TOWER 2, LEVEL 23 DARLING PARK, 201 SUSSEX ST SYDNEY NSW 2000

LDA/2016/0395 – 25-27 EPPING ROAD, MACQUARIE PARK

ATTACHMENT A – AMENDED ARCHITECTURAL DRAWINGS

Figure 1 – Amendments to top level of Building K Lot 105

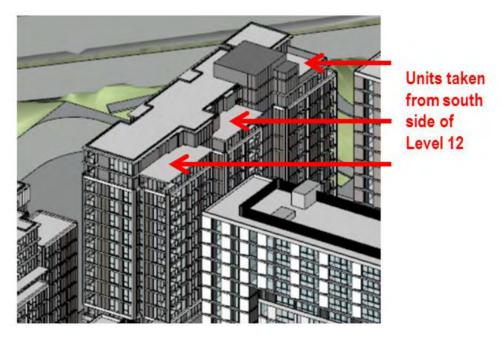
- Deletion of 3 units on the southern side of top level of Building K Lot 105 (refer Figure 1); and
- Amend the layouts of 66 units in Building K Lot 105.

The new stepped section of Building K as a result of deleting the 3 units on the top level of Building K reduces overshadowing of some apartments in Building M and Building L3, and increases solar access availability for communal open space.

LACHLAN'S LINE NORTH RYDE **Block Plans** Level 03 Block Plan J 20.11.17 KD APARTMENT LAYOUTS AMENDED
Rev. Date Approved by Revision Notes Dwg No. **DA-110-003** For Information

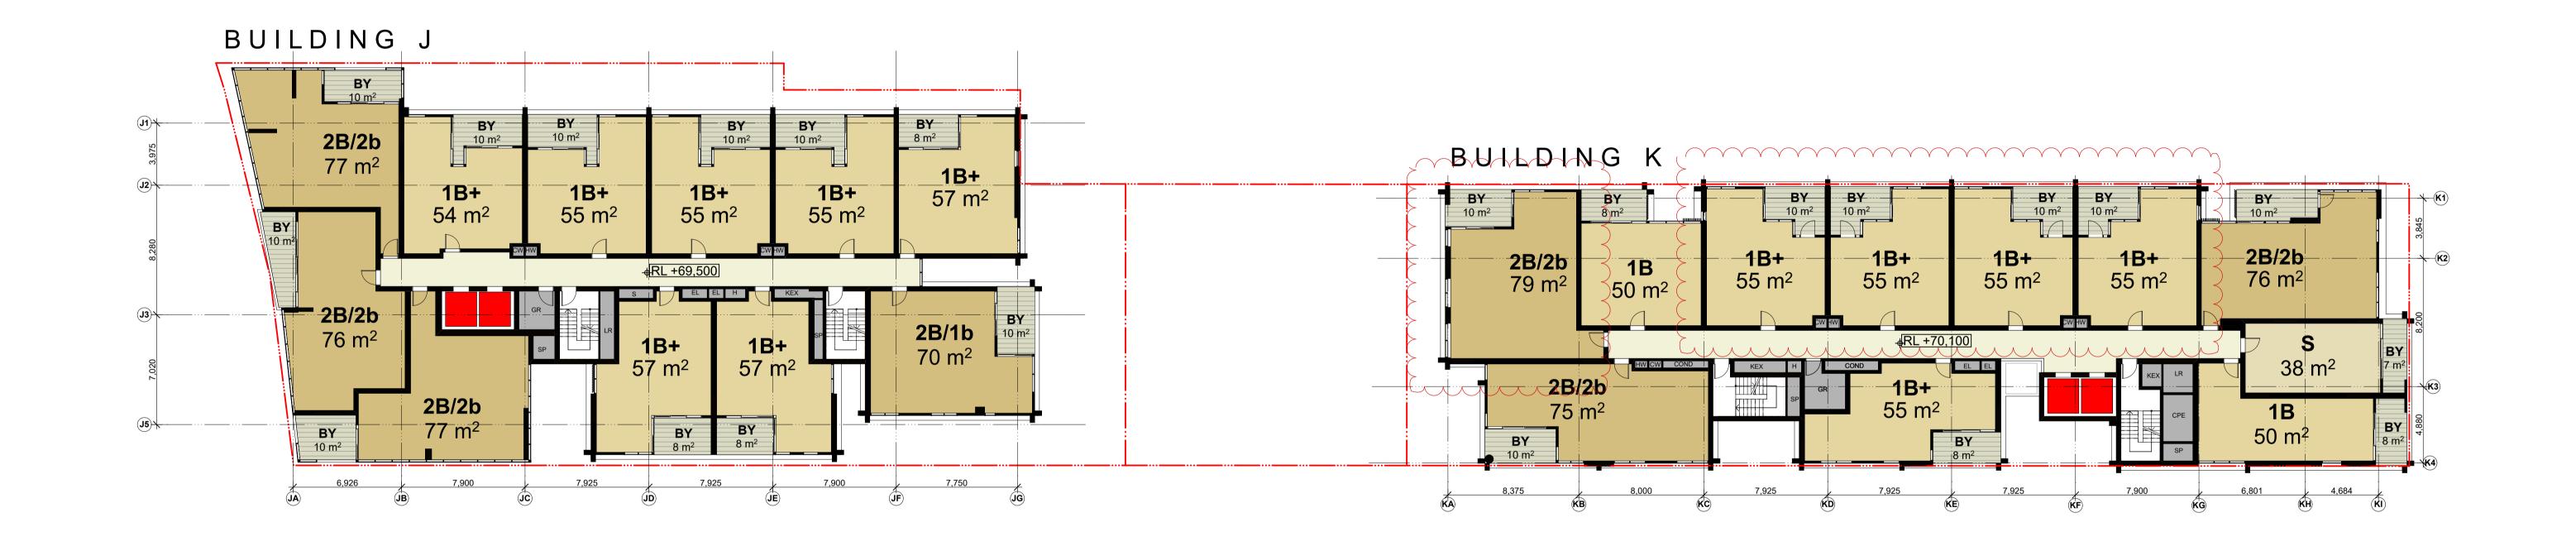
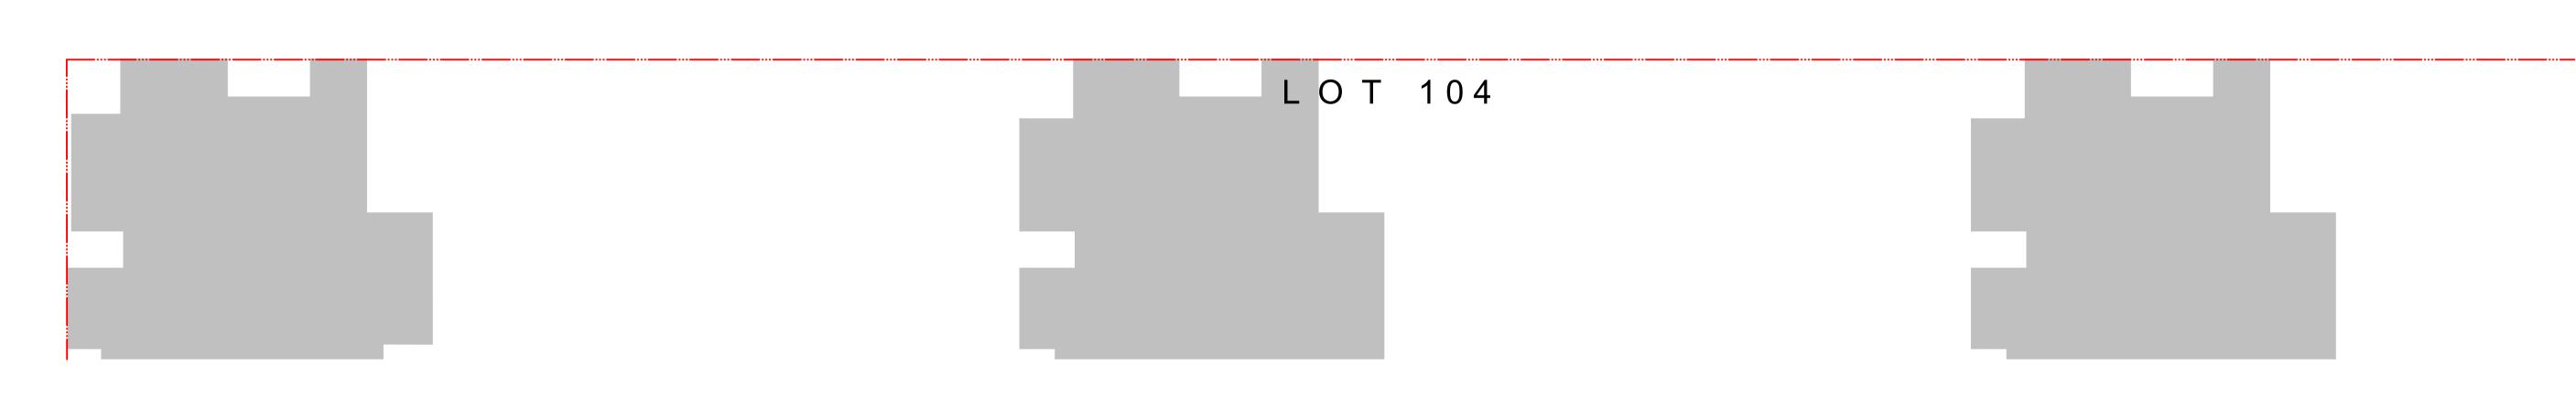
- Amend the layouts of 66 units in Building K Lot 105; and
- No change to the heights of buildings.

The layout of a significant number of units in Building K, have been re-planned which has allowed those apartments to qualify for over two hours of sun on June 21. The layout changes involve reconfiguring the living rooms, balconies and bedrooms to provide more glazing along the building façade of Building K, which has had the effect of optimising solar access to living rooms and private open spaces to those units.

Figure 1: Further improved Option F

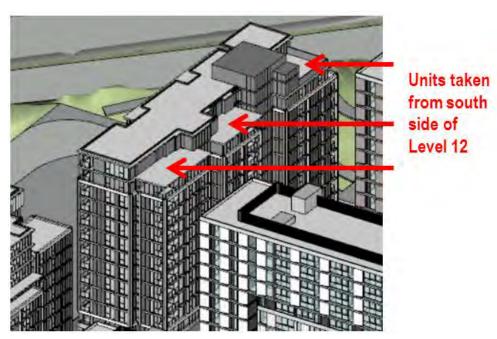
In generating the preferred Option F massing change, mismatch between overall floor plate sizes of the four buildings resulted in some excess GFA. This excess area is now eliminated by removing three apartments from the south side of Level 12 of Building K. It is expected that the new stepped

The need to match the GFA of the preferred Option F to that of the current DA has been met by deleting three apartments on the shaded side of Level 12 in Building K, producing a stepped section. This incremental massing change removes some overshadowing of a number of apartments in Buildings M and L.3, further improving the Option F overall solar access compliance.

Figure 2: Key plan. Shadows are at 10:30am June 21

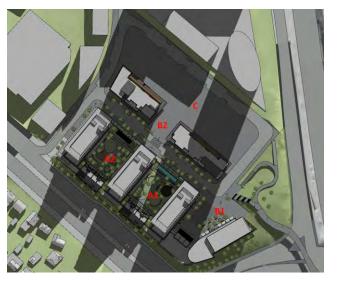
The improved Option F scheme presents further small but key improvements in solar access to communal open space, when compared to the current DA scheme. I update my previous estimated proportions sunlit spaces, in the same two categories annotated on Figure 2:

Figure 4: Comparison of winter and Equinox. 12pm views from the sun.

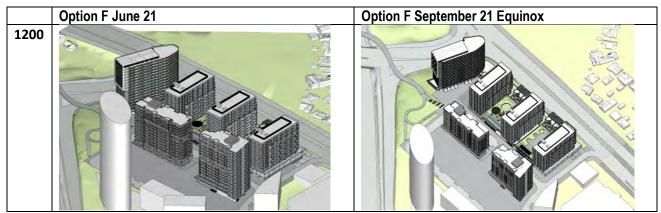
Figure 4 compares the views from the sun at noon for Option F. This effect is very similar for both current DA and improved Option F schemes.
